Response to Comments on Draft National Pollutant Discharge Elimination System (NPDES) Permit No. MA0003905 - General Electric Aviation (GE)

In accordance with the provisions of 40 C.F.R. §124.17, this document presents EPA’s and the Massachusetts Department of Environmental Protection’s (MassDEP)¹ responses to public comments received on the Draft NPDES Permit (MA0003905) for General Electric Aviation’s facility in Lynn, Massachusetts (GE). This response to comments (RTC) document not only provides responses public comments, but it also explains and supports the EPA and MassDEP determinations that underlie the Final Permit.

Figure 10.3.1 Comparison of GE's Case 5 and Case 2 modeling results including power generation, river flow, and intake flow for the period from July 1 through September 30.

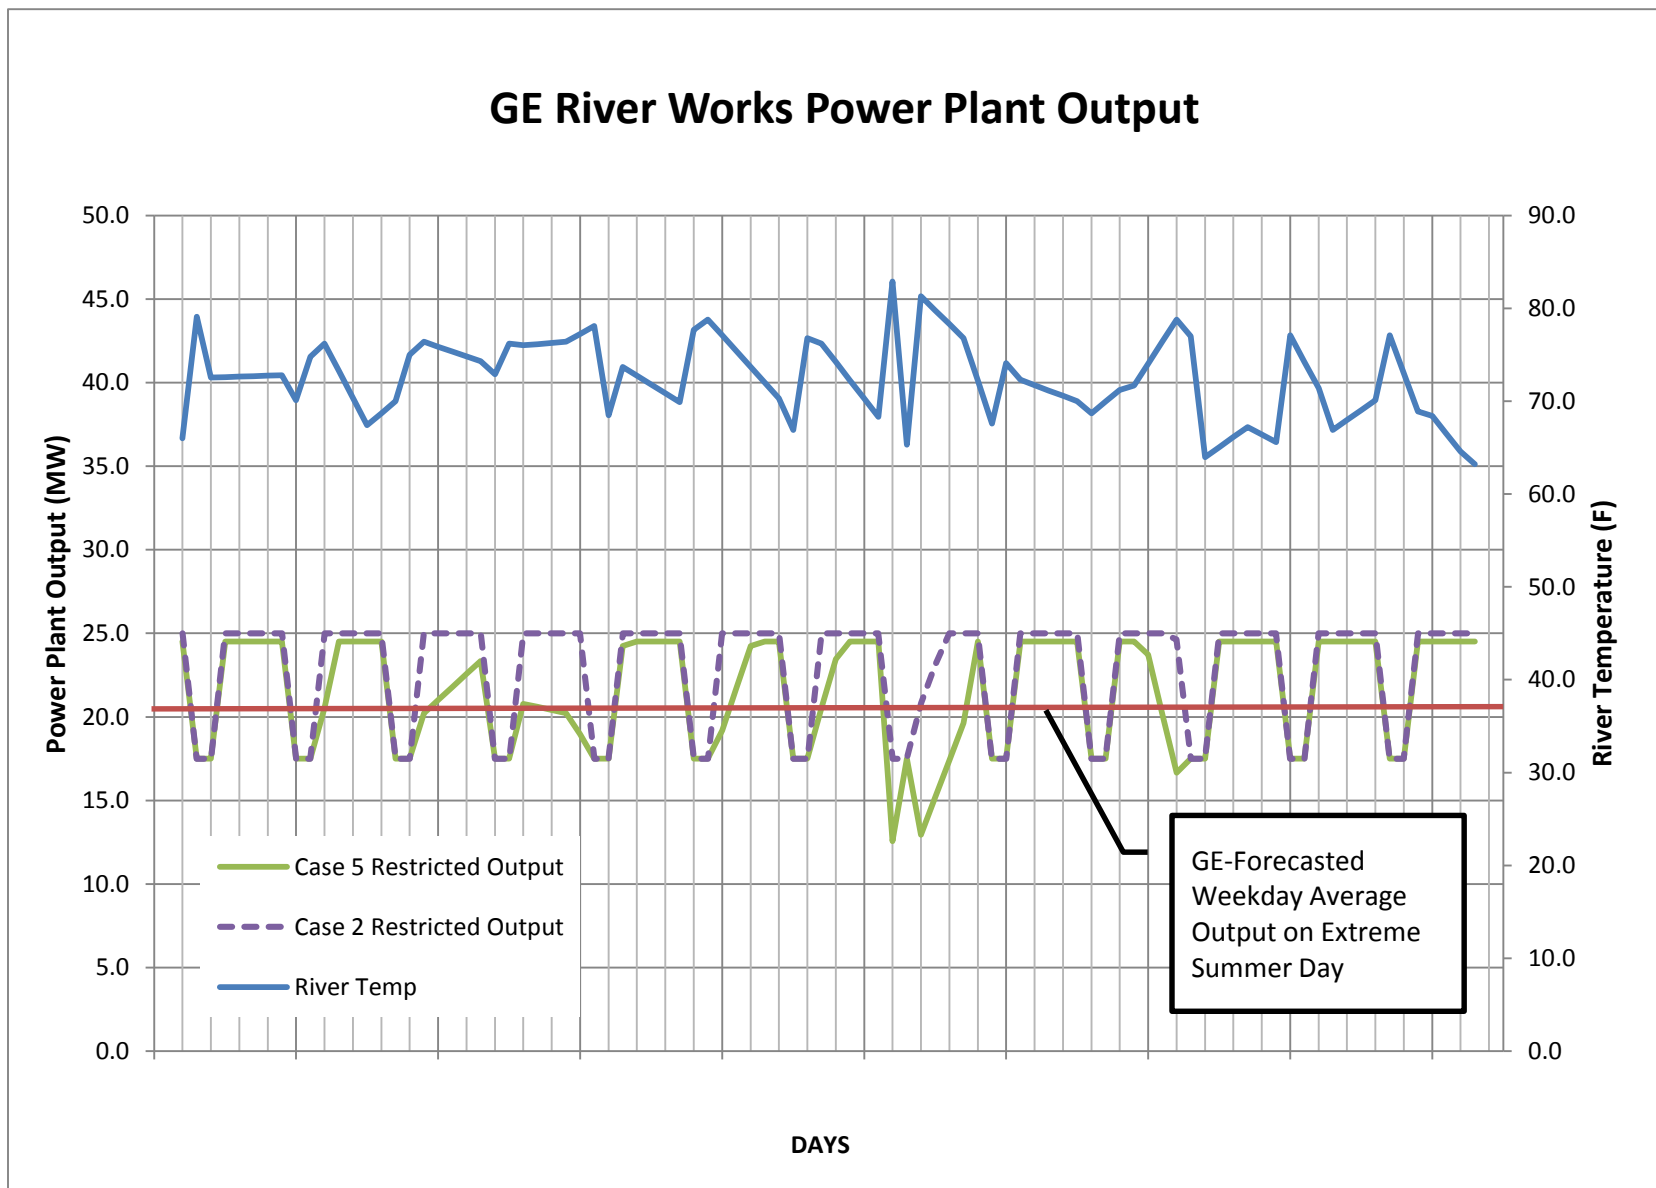
EPA compared power output between “Case 5” and “Case 2” for the July 1 through September 30 time period, when biological impacts on the aquatic community from thermal discharge would be most likely to occur (Figure 10.3.1). Under Case 5, weekday power output is expected to be restricted further than GE’s proposed 30% reduction on approximately 25 days per year, and the average weekday power output is anticipated to be about 23 MW (34% reduction). This can be compared to an average weekday power output of 25 MW (a 29% reduction) under Case 2. In both cases, the weekend power output generally meets the required level (17.5 MW). For Case 5, the projected minimum output is about 13 MW (a 63% reduction), which occurs when the intake temperature is at its peak (greater than 81°F). This condition is expected to occur rarely; based on the recorded intake temperature between 2001 and 2004, the projected intake temperature would be anticipated to exceed 80°F on approximately two days per year. Based on analysis of GE’s operational model, the anticipated average daily output from the Power Plant under Case 5 (maximum temperature limit of 90°F) during the summer would not be expected to be substantially less than the expected average daily output during the summer for GE’s proposed operating conditions under Case 2, provided that GE is authorized to intake a higher volume of water equivalent to the maximum daily flow limit of 35.6 MGD with no reduction in average monthly flow during this period.

According to GE's model, the average daily output from the Power Plant on an extreme summer day (based on a Forecast from August 6, 2009) is 20.2 MW with a once-through cooling flow of 35.6 MGD. Under Case 5, the Power Plant output is expected to be less than 20.2 MW on only approximately 7 days per year. Operational profiles from GE indicate that the average hourly steam use during the summer (July to September) for heating, manufacturing, and test steam is less than 40,000 million pounds per hour (Mlb/hr) and generally less than 20,000 Mlb/hr (See Figure 10.3.1). This is consistent with GE's characterization of limited operations during the hottest months. During July through September, GE's plant operation profiles indicate that only the 200 psig steam is produced. From this assessment, EPA concludes that applying the more stringent temperature limit of 90°F during summer could be feasible if the facility were authorized to intake an average monthly flow limit of 35.6 MGD.

Nevertheless, EPA has concluded that, based on available information, a year-round discharge temperature of 95°F would reasonably assure protection and propagation of the BIP because the primary thermal impacts of concern appear to be limited in both size and duration and organisms would likely be able to avoid conditions that could result in acute toxicity. At a higher discharge temperature, the average monthly flow can be reduced by 20% year-round, including summer months when early life stages may be present, which will reduce mortality due to entrainment and impingement and further protect the BIP. Therefore, the Final Permit applies a year-round maximum discharge temperature limit of 95°F and an average monthly flow limit of 28.5 MGD at Outfall 018. In addition, according to GE, the steam requirements of the Test Cell are limited in summer, which should reduce the potential thermal impacts on those days when the ambient temperatures are likely to be highest.

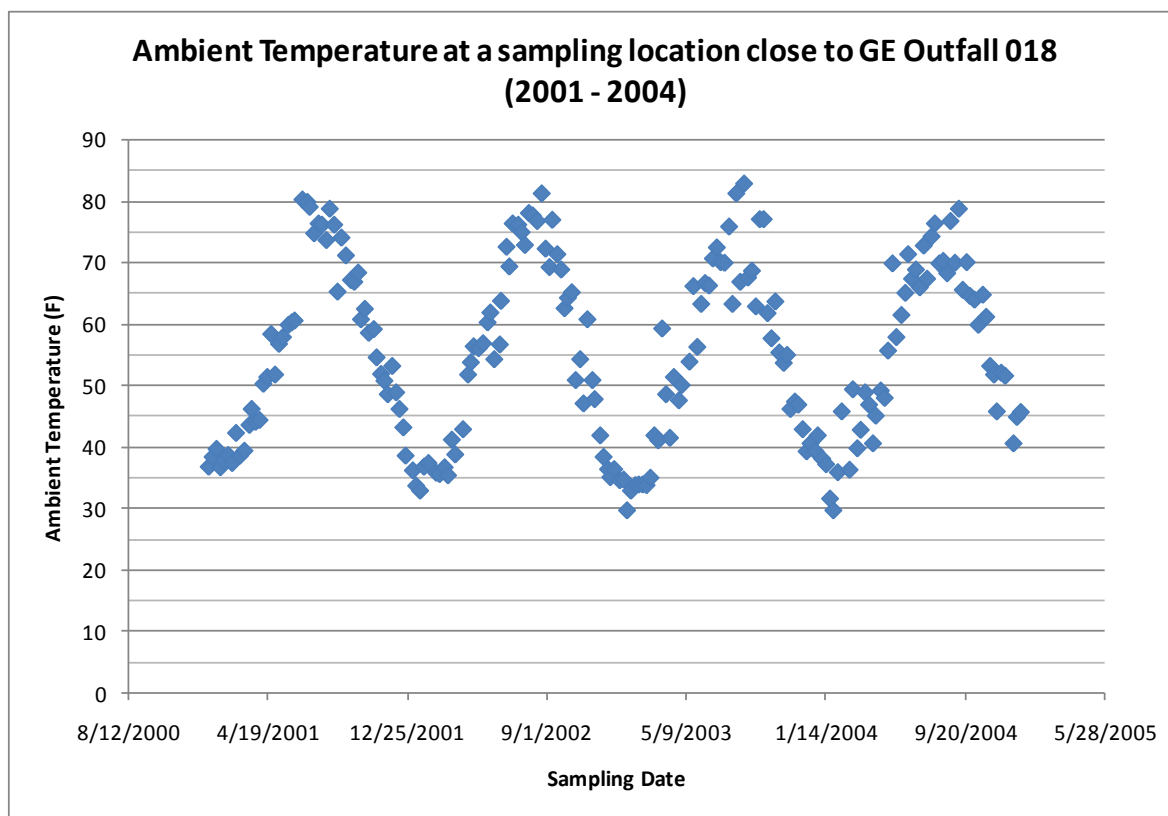
Available ambient data support this conclusion. In its § 316(a) determination for the Wheelabrator Saugus facility, on which EPA relies heavily, the Agency concluded that available data indicate that no appreciable harm to balanced indigenous populations ("BIP") of fish has occurred from existing thermal discharges at Wheelabrator Saugus under conditions which included the existing thermal discharge from GE. Fact Sheet Attachment K, p. 16. Indeed, according to EPA, those conditions include at least some discharges by GE during August, 2001, at currently permitted discharge levels (Fact Sheet, p. 78).

Below is a summary of weekly ambient temperature for 2001-2004 at a sampling location close to GE Outfall 018 but outside the projected thermal plume impact zone, which includes data for the August 2001 time period cited by EPA. These ambient temperature records showed that EPA's *ad hoc* 85°F threshold was not exceeded in 2001 - 2004.

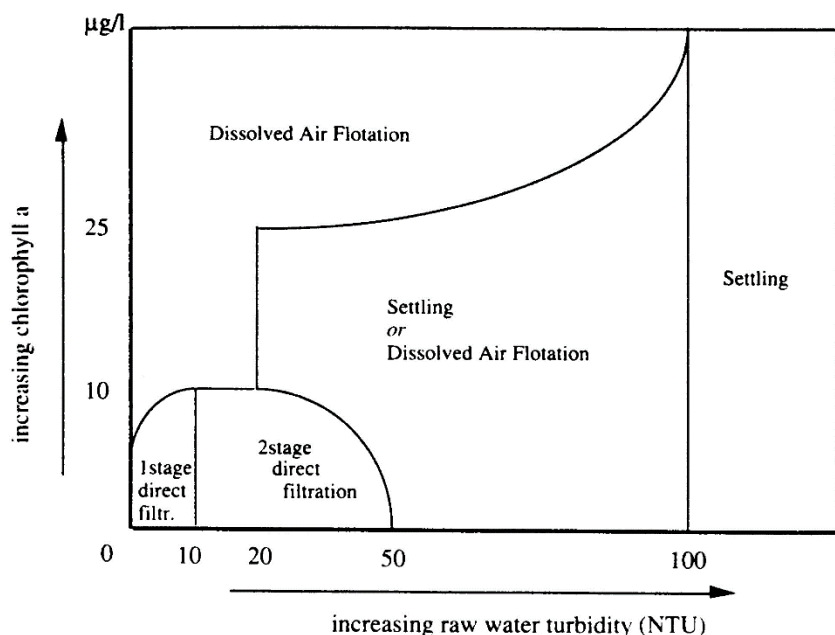
Comment 13.1: Treatment by GAC Alone is more Effective than Treatment using both the GAC and DAF.

EPA assumes that “pollutant discharges would be reduced the most by operating the CDTs in the mode utilizing both DAF and GAC treatment.” Fact Sheet p. 8. However, this assumption is not correct. To fully understand this issue, it is critical to first address the original design philosophy of the CDTs, and to compare this design philosophy to GE’s actual operating experience over the last ten years.
